# HISTORIC AND DESIGN REVIEW COMMISSION

September 20, 2023

**HDRC CASE NO:** 2023-367  
**ADDRESS:** 146 NAVARRO ST  
203 S PRESA ST  
**LEGAL DESCRIPTION:** NCB 125 BLK LOT 13 (CPS ENERGY NAVARRO)  
**ZONING:** D, H, RIO-3  
**CITY COUNCIL DIST.:** 1  
**DISTRICT:** La Villita Historic District  
**APPLICANT:** Humberto Aguillon/GarzaEMC  
**OWNER:** Clay Bain/BH 146 NAVARRO STREET LLC  
**TYPE OF WORK:** Construction of a parking lot  
**APPLICATION RECEIVED:** August 30, 2023  
**60-DAY REVIEW:** October 29, 2023  
**CASE MANAGER:** Edward Hall

The applicant is requesting a Certificate of Appropriateness for approval to construct a surface parking lot at 146 Navarro. The proposed surface parking lot will feature approximately 14 parking stalls and will be located in an existing, pedestrian plaza feature.

**SITE PLAN**

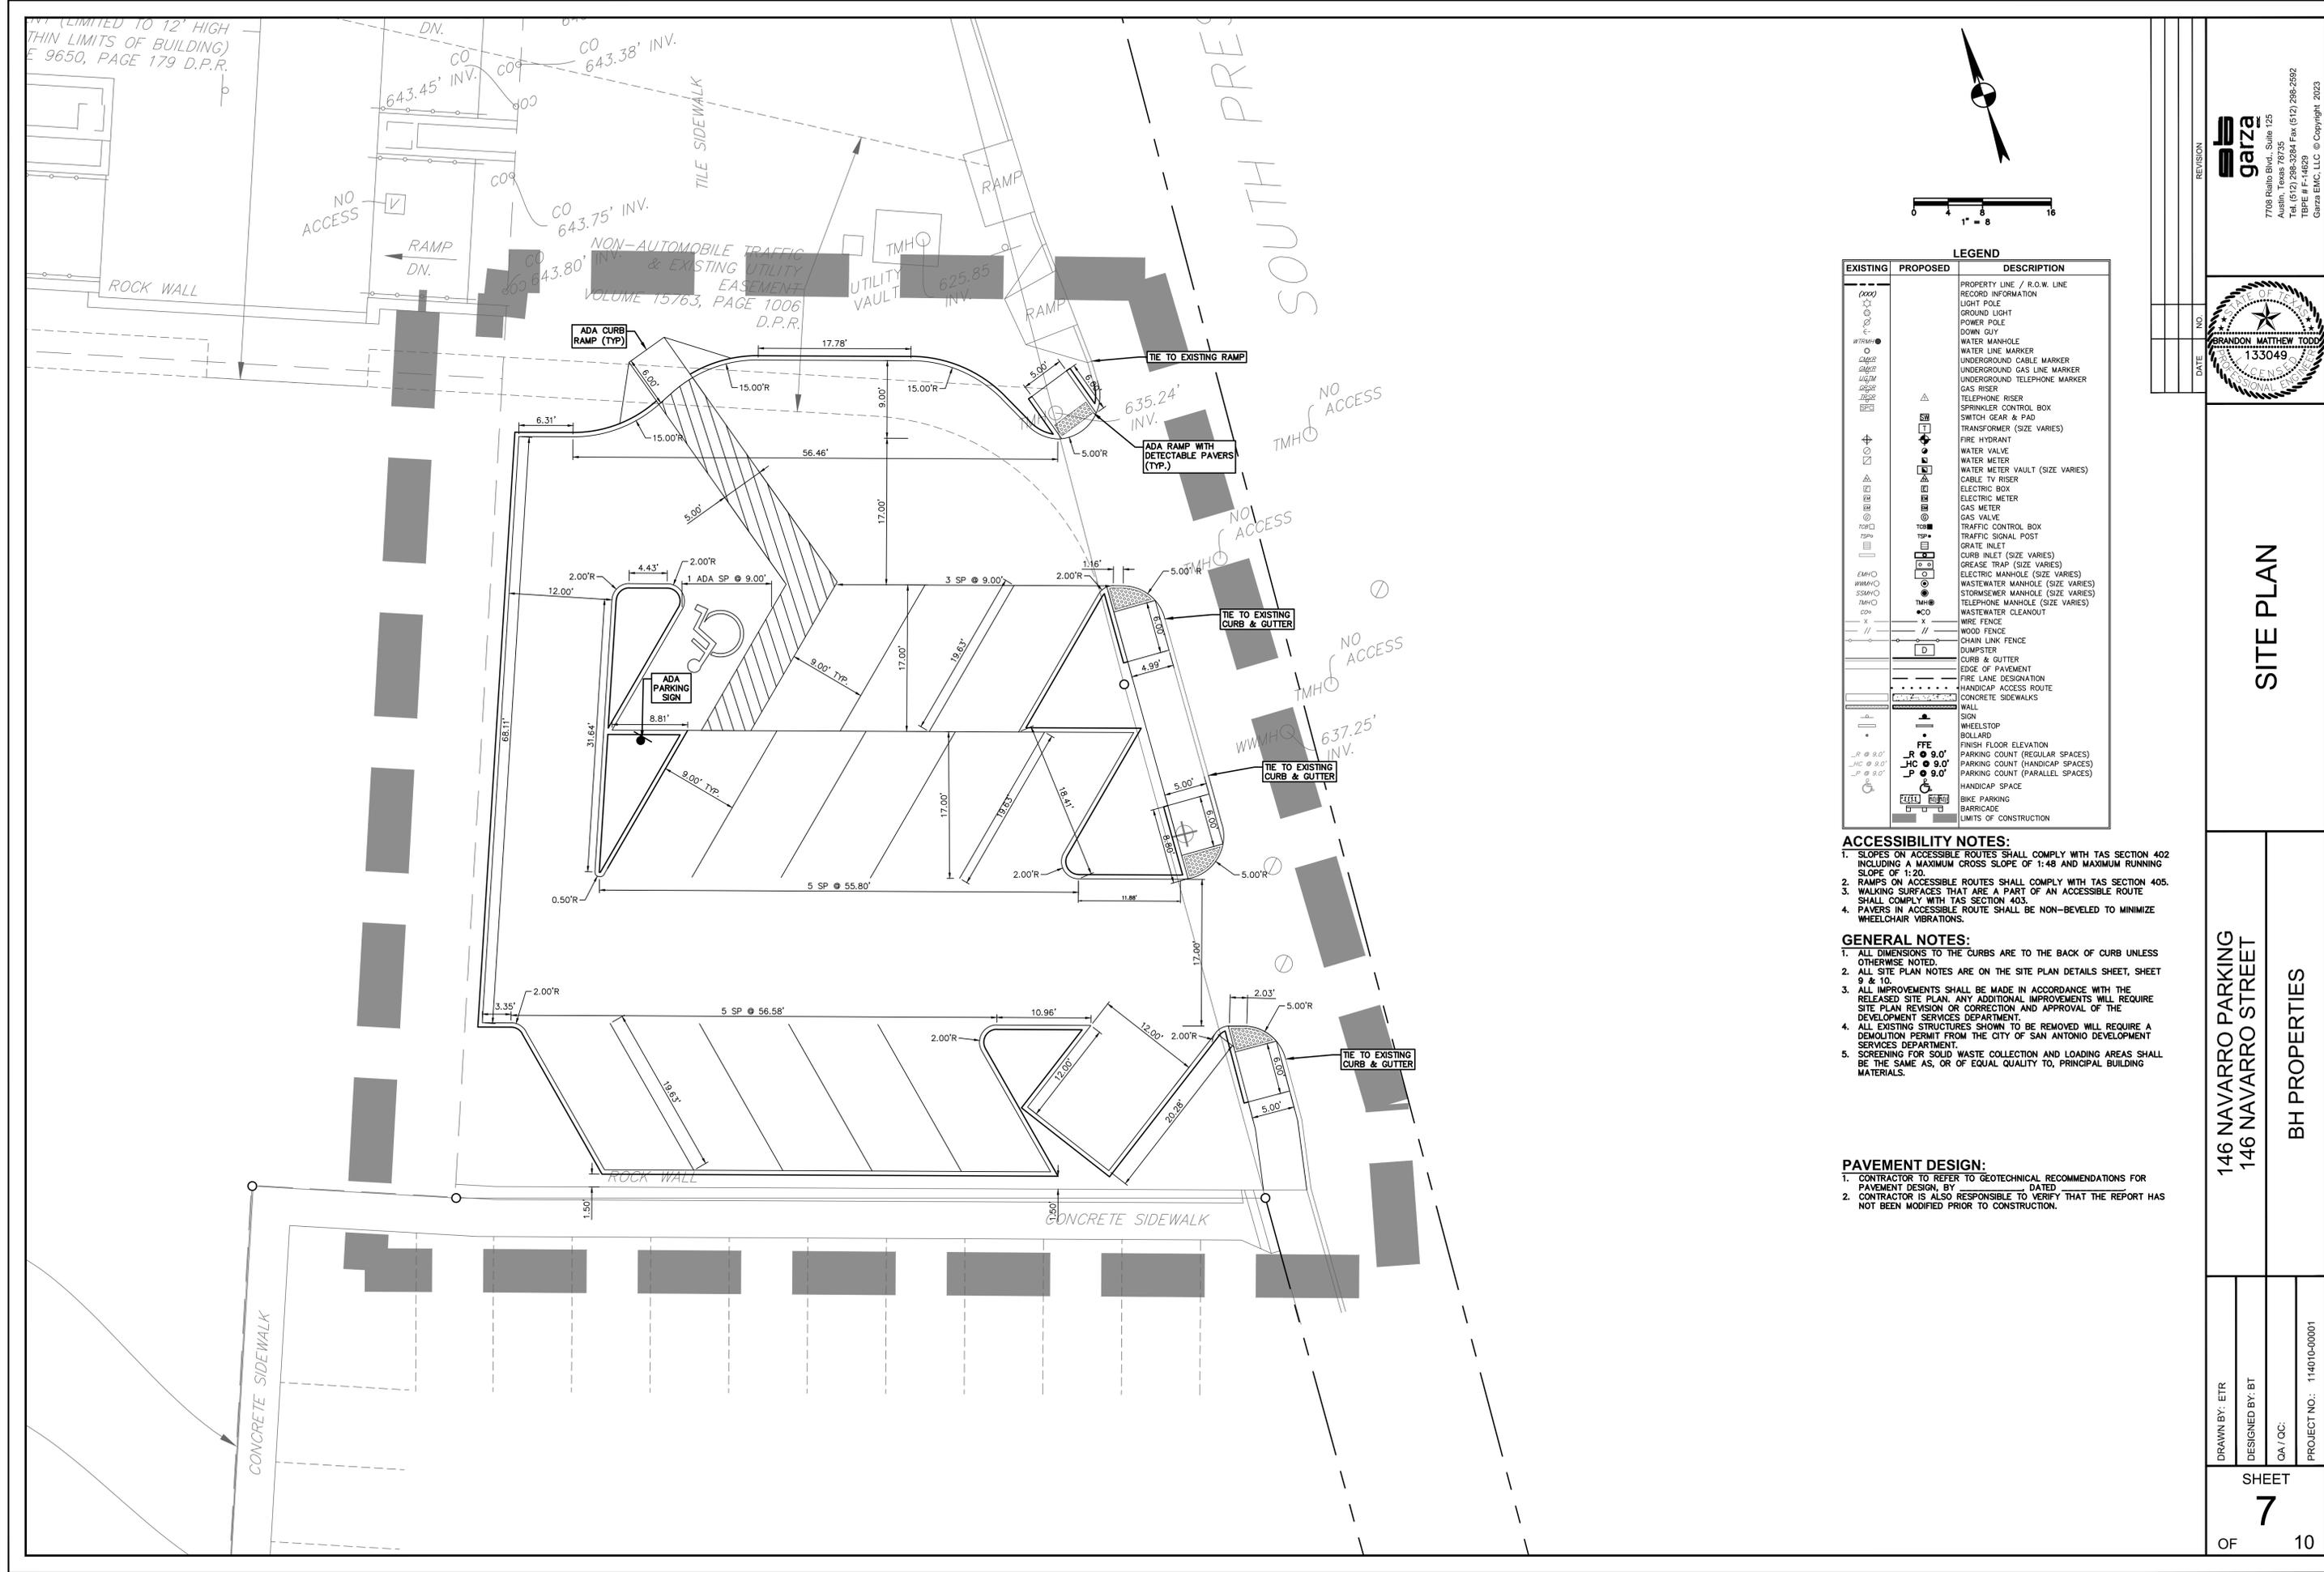
- b. **PARKING** – The Downtown Design Guide Chapter 4 notes that off-street parking should be located below or behind buildings, should be integrated into the project that it serves and should not be visible on the ground floor of any building façade that faces a street. Per the UDC Section 35-672, the extent of parking area that may be located along the street, river, or creek edge shall be limited to a percentage of the lot line as per Table 672-1 as measured in a lineal direction parallel to the lot line. The UDC notes that the lot line parking percentage for RIO-3 is not applicable; therefore it is not recommended in RIO-3/downtown, adjacent to the street. Staff finds the proposed parking to be inconsistent with the Downtown Design Guide and the UDC.

- c. **BUFFERING** – For RIO-3, parking that is within a twenty (20) foot setback from a property line adjacent to a street must be screened with a landscape buffer that at minimum features the following (Type B from Table 510-2, Section 35-510). This requirement would include a buffer yard that is at minimum fifteen (15) feet wide, features at least two canopy trees, two understory trees, at minimum six large shrubs, eight medium shrubs, and six small shrubs. Staff finds that the UDC’s standards regarding buffering should be met.

- d. **DUMPSTER ENCLOSURE** – The applicant has proposed a dumpster to be located adjacent to the property line and public right of way. Per the UDC Section 35-672(m), service areas should be visually unobtrusive, should be integrated into the design of a building or site, should be located away from major streets, and doors of trash enclosures should be oriented to face away from the street. Staff finds the proposed dumpster enclosure’s location to be inconsistent with the UDC. Staff finds that the on-site dumpster enclosure should be located and design to be appropriate and consistent with the UDC.

Staff does not recommend approval based on findings b through d. Staff recommends the applicant amend the proposed site and parking design to be consistent with the Downtown Design Guide and the UDC. This would include the relocation and screening of the proposed dumpster enclosure, buffering and screening of parking consistent with the Downtown Design Guide and the UDC and would likely result in a significant reduction in surface parking. Additionally, staff recommends the applicant relocate and amend the proposed dumpster enclosure to be consistent with the UDC.
